Würth Elektronik eiSos GmbH & Co. KG EMC & Inductive Solutions

Product / Process Change Notification (PCN)		
PCN #:	PCN_ConCRD_20201001	Change Category:
Affected Series:	WR-CRD 693063020911	□ Equipment / Location□ General Data□ Material
PCN Date:	July 01, 2020	□ Process
Effective Date:	October 01, 2020	☑ Product Design☐ Shipping / Packaging☐ Supplier
Contact:	Product Management	Data Sheet Change:
Phone:	+49 (0) 7942 - 945 5001	⊠ Yes □ No
Fax:	+49 (0) 7942 - 945 5179	Attachment:
E-Mail:	pcn.eican@we-online.com	□ Yes ⊠ No

DESCRIPTION AND PURPOSE OF CHANGE:

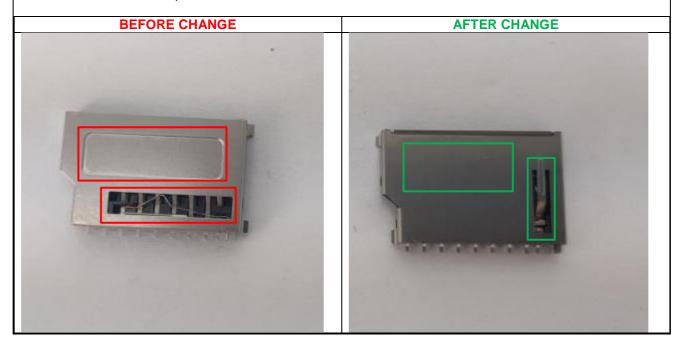
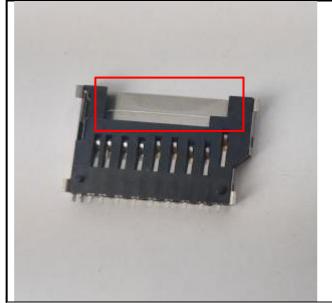
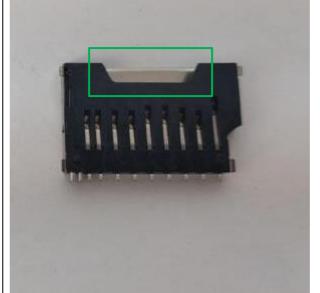
Due to an improvement of the production capability, Würth Elektronik has reworked the design of this item while retaining full compatibility with the previous version.

- Modification of the card detection switch for a more durable one
- Modification of the shape of the back insulator

- No change in materials has been done
- No change in PCB layout has been done
